From: [Brian Moench](#)
To: [Wren, Kira](#)
Cc: [John Collins](#); [Kris Thompson](#)
Subject: RE: #57-008 Copy of Notice of Violation and Proposed Agreed Order. GFL Solid Waste Midwest LLC. Case No. 2023-29526-S.
Date: Wednesday, June 26, 2024 5:21:44 PM
Attachments: [image002.png](#)
[image003.png](#)
[image004.png](#)
[image005.png](#)
[image006.png](#)
[image007.png](#)
[image008.png](#)
[image009.png](#)
[image011.png](#)
[image012.png](#)
[image001.png](#)
[21312 A-Plot-Existing Building As-Built A101 06-26-24.pdf](#)
[21312 C-Plot All ASB-C201 6-26-24.pdf](#)

Bunn Box, Inc. - Transfer Station
 2164 Production Road
 Kendallville, Indiana 46755
 Wayne Township - Noble County
SITE PLAN - AS-BUILT

Bunn Box, Inc. - Transfer Station
 2164 Production Road
 Kendallville, Indiana 46755
 Wayne Township - Noble County
FLOOR PLAN - AS BUILT

C201 -AB

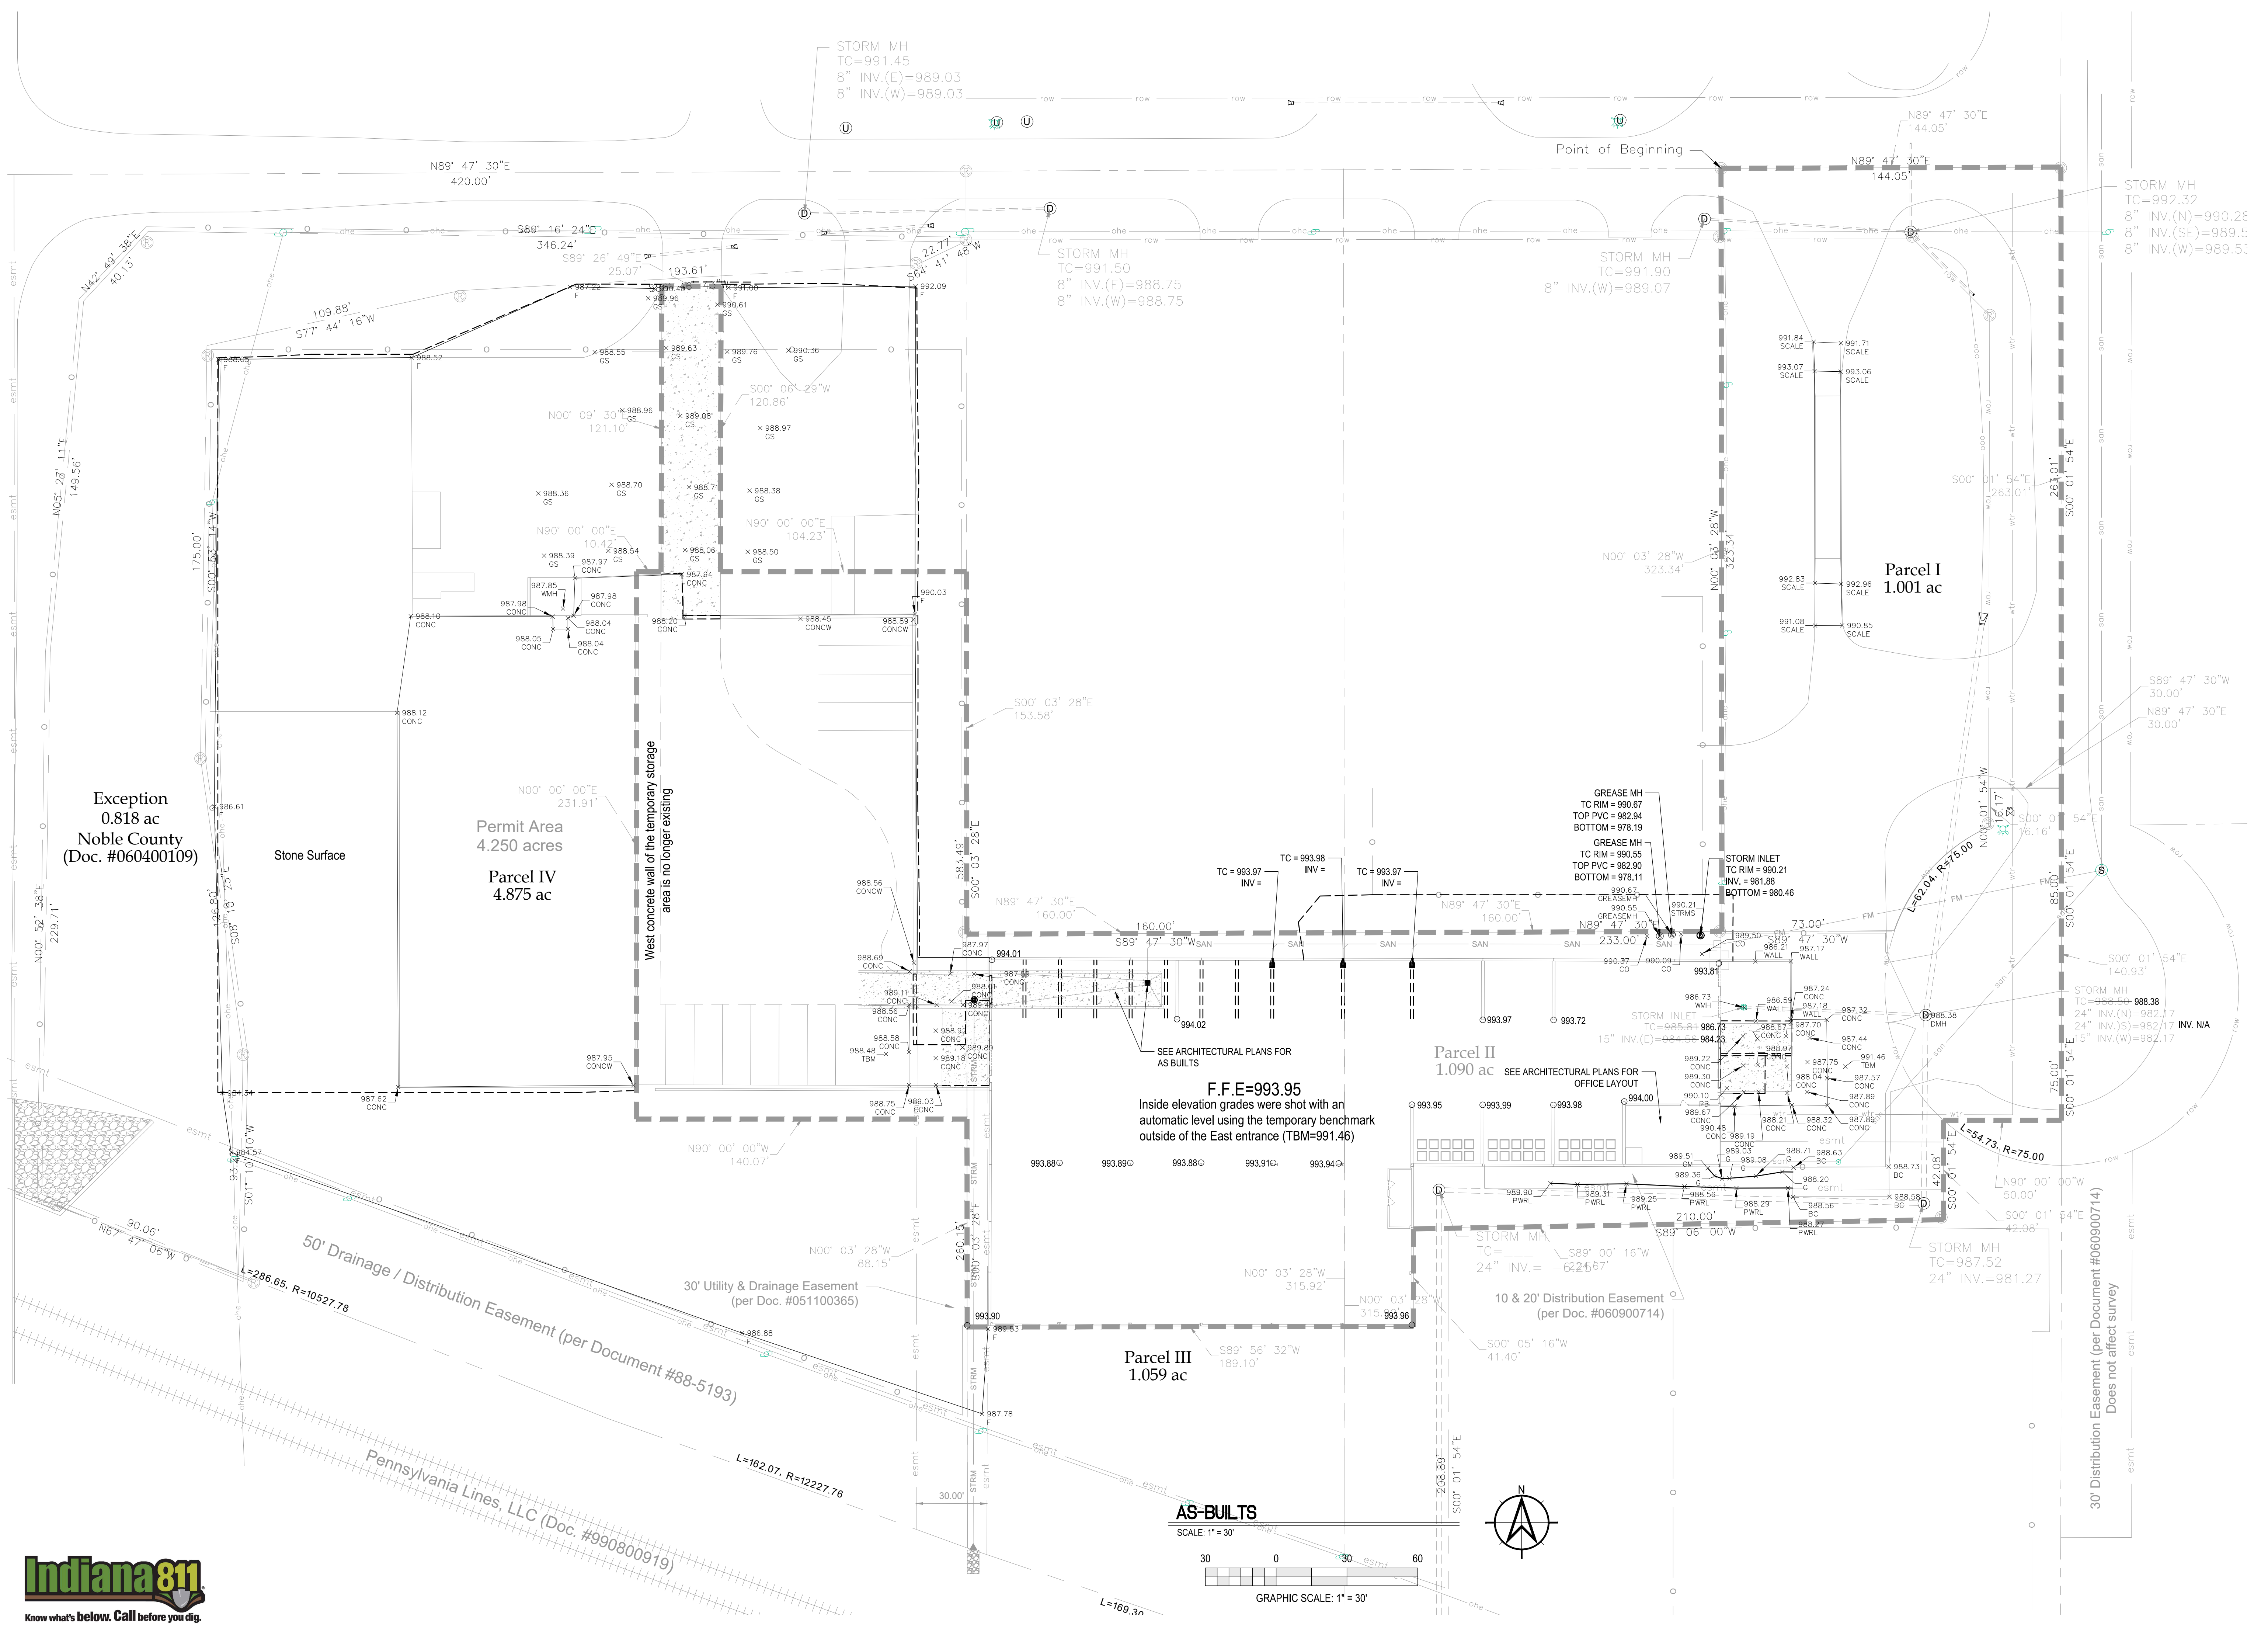
- Removal of west bounding wall in the temporary storage area,
- Elevations of each corner of the waste processing areas (existing concrete floor),
- Slope breaks in the concrete floor,
- Pipe inverts and top of castings for the tipping floor inlet structures.

Additionally, many of the spot grades shown within the as-built drawings are not legible due to overlapping one another. The as-built drawings should be resubmitted to include all required information and to reflect the final conditions of the site. The as-built drawings must be legible.
